# CLEPA COMMENTS TO VRU-PROXI-17-08

VRU-Proxi-19-03

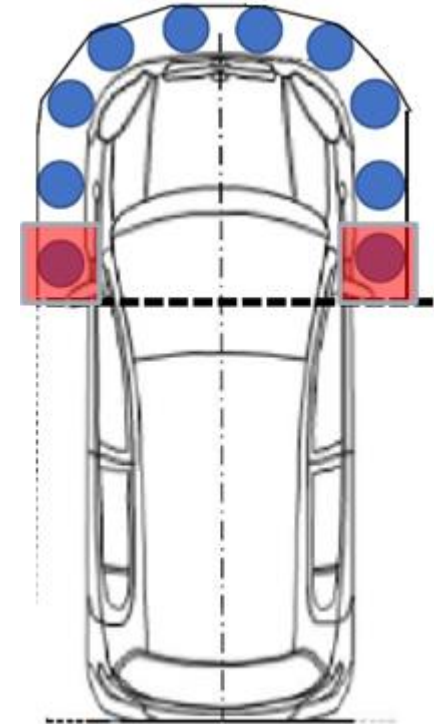
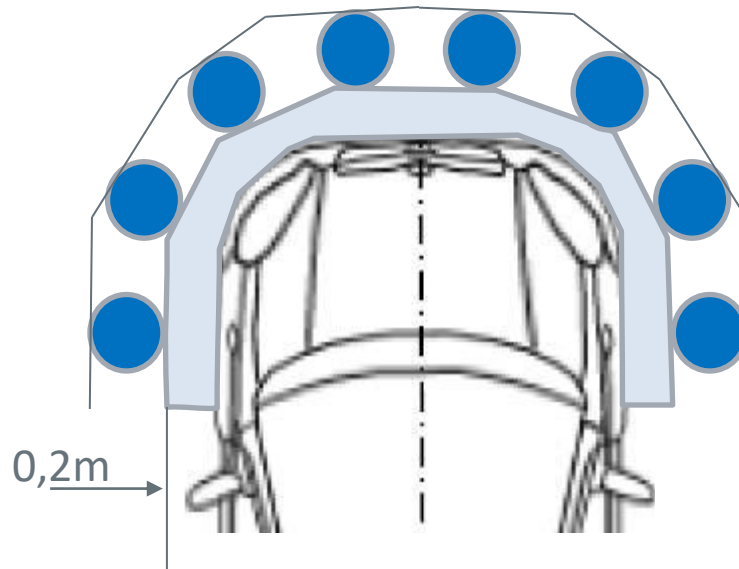
- CLEPA proposal:
  - Remove the poles closest to the rear mirrors (relevance in accidentology?)
  - Increase distance of poles of 0,2m also for indirect vision systems
